Submission to:

**GenCost 2019-20: preliminary results for stakeholder review**

March 2020

Figure 1 Levelised cost of electricity (LCOE) for SMR, inputs as per Table 4

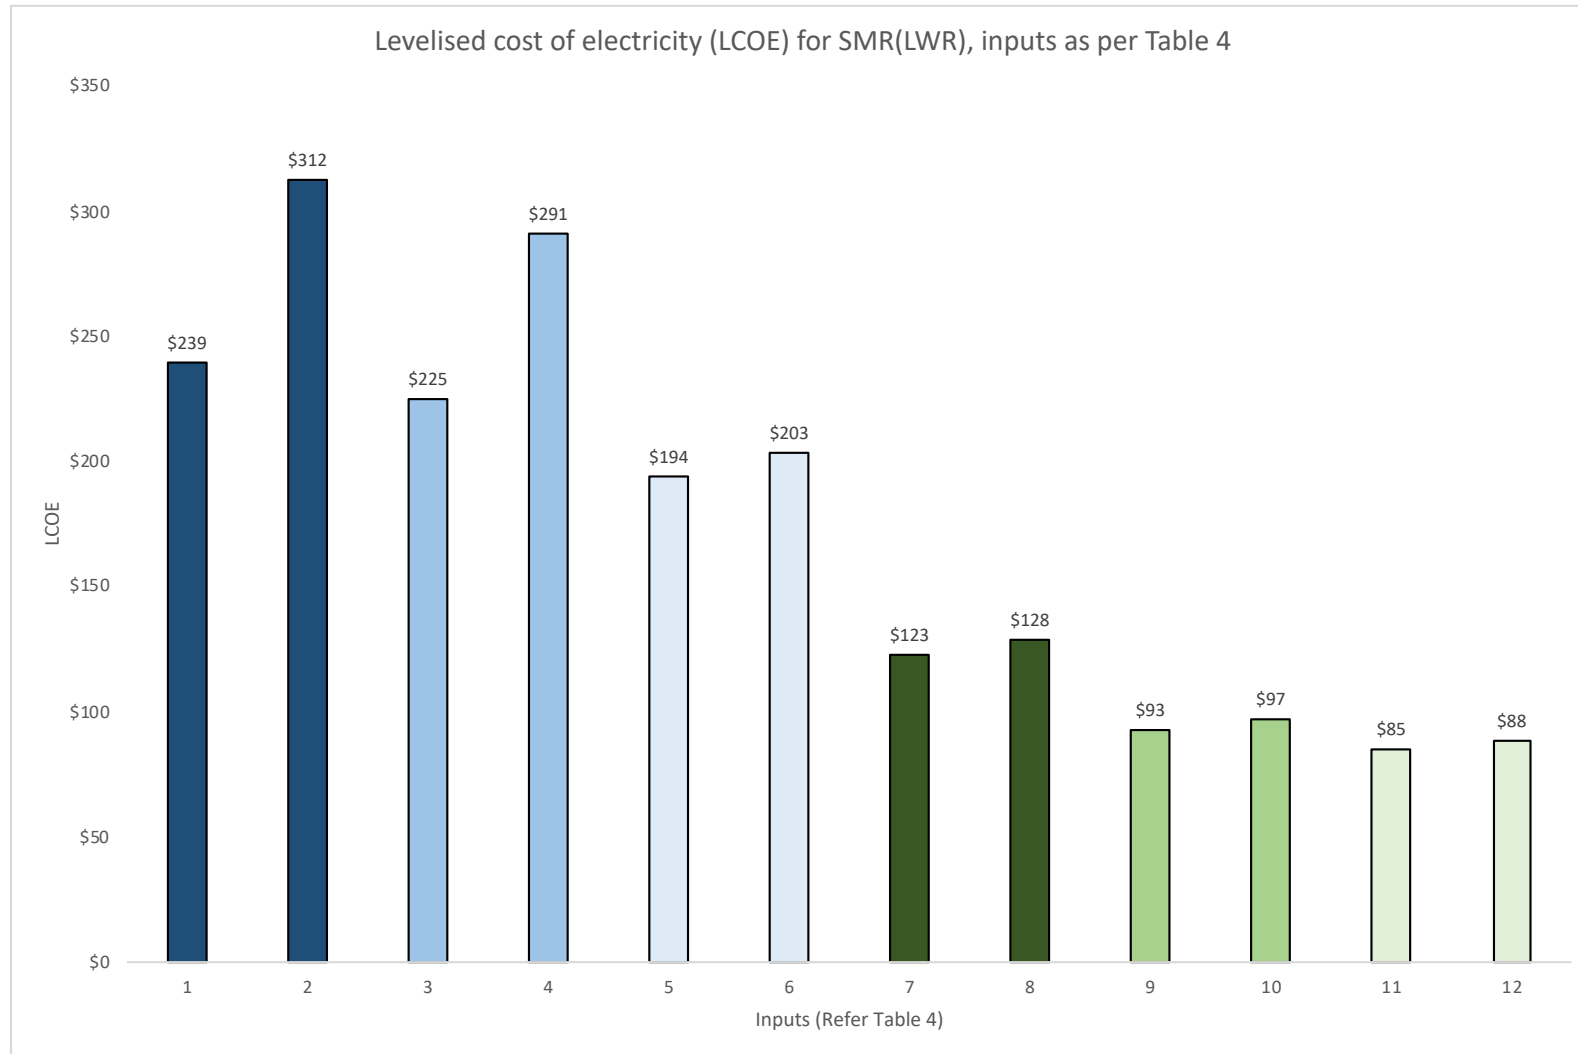
We recommend the Draft is updated to publish SMR(LWR) LCOE on the basis of inputs (5) and (6) in Table 4 below. These variable sets have included:

- Corrected fuel cost = \$0.60/GJ
- Corrected Fixed O+M cost = \$50/kW
- Corrected thermal efficiency = 30%
- Capacity factor for Low Price = 95%
- Capacity factor for High Price = 90%
- Capex based on a 50% loading of the FOAK cost recently provided by the leading global SMR vendor

Our results are summarised in Table 4 and Figure 1 below.

Figure 2 Levelised cost of electricity (LCOE) of SMR(LWR), showing impact of varying build time, discount rate, and capex

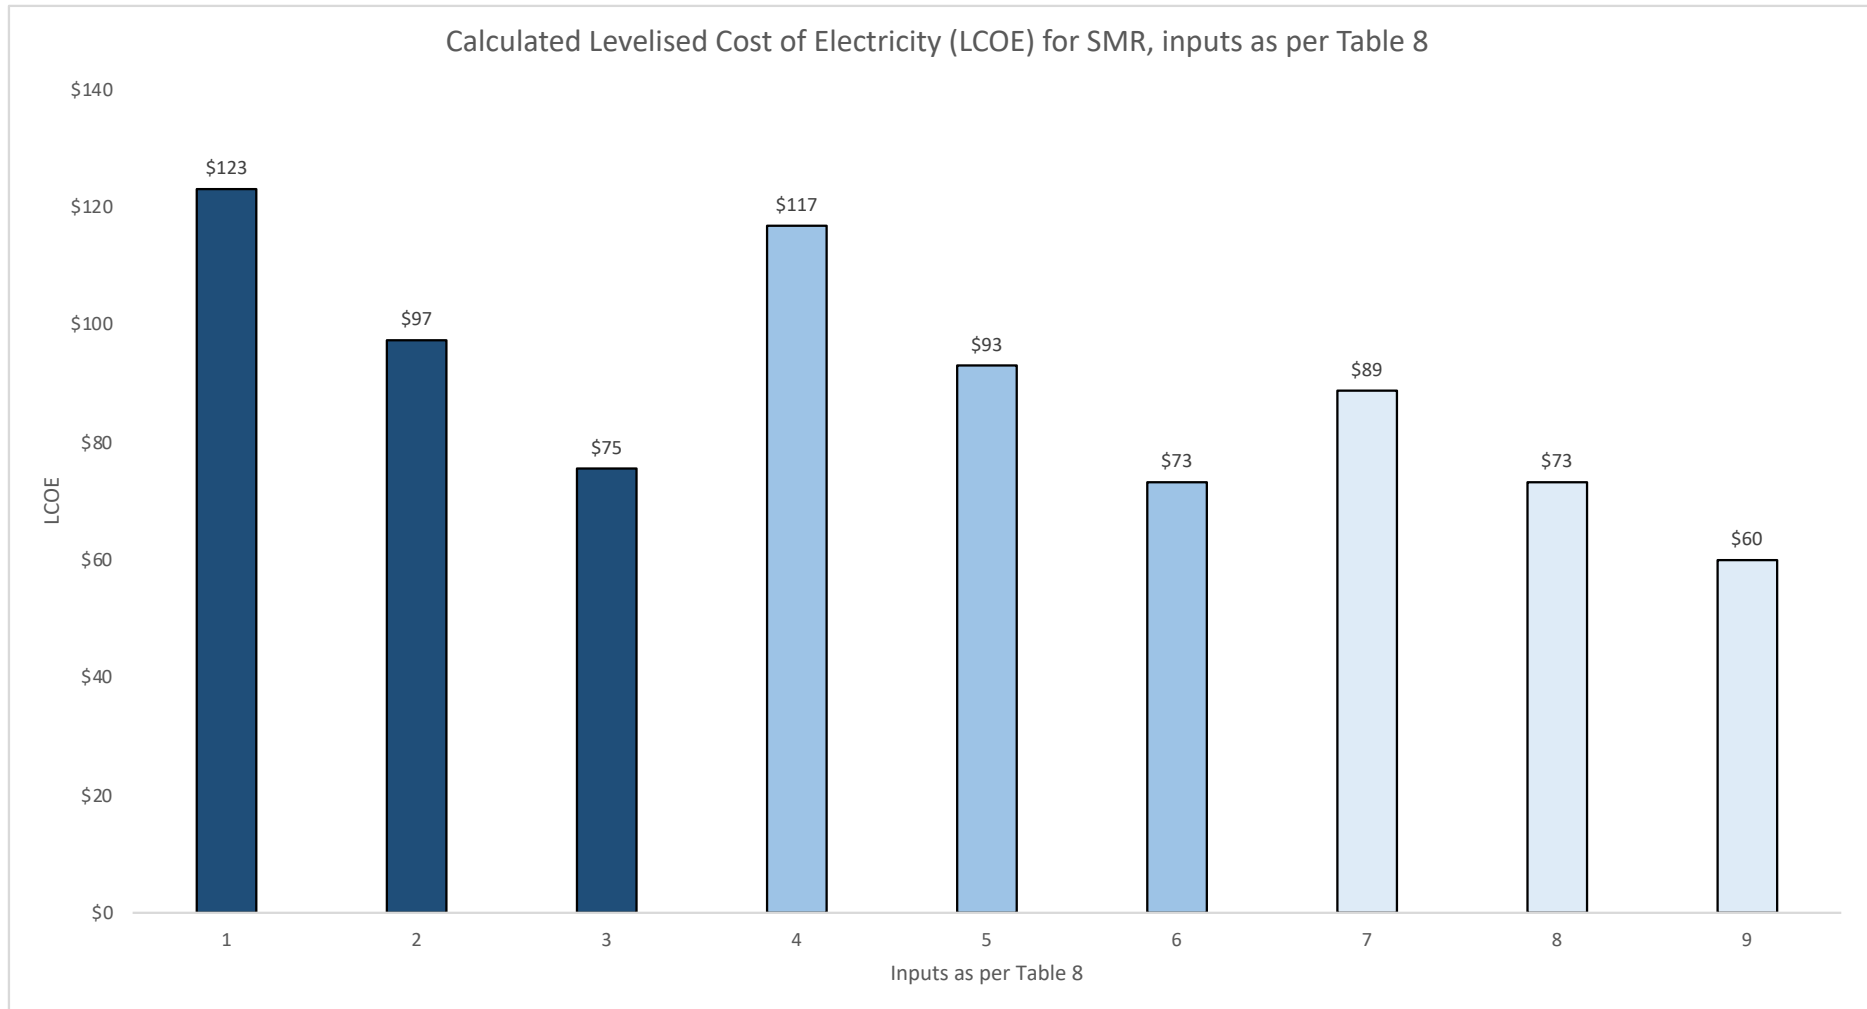
By contrast, if the discount rate is reduced to, for example, 5 % or lower, low-carbon assets (irrespective of them being nuclear, renewable or fossil with CCS) with larger upfront capex and build time, and longer design lives, are appropriately recognised for delivering value several generations into the future.

This is important for developing policy to transition entire economies to decarbonised energy sources. Even using FOAK capex with 50% loading, the LCOE of SMR(LWR) falls under \$100/MWh by reducing the discount rate to 5%.
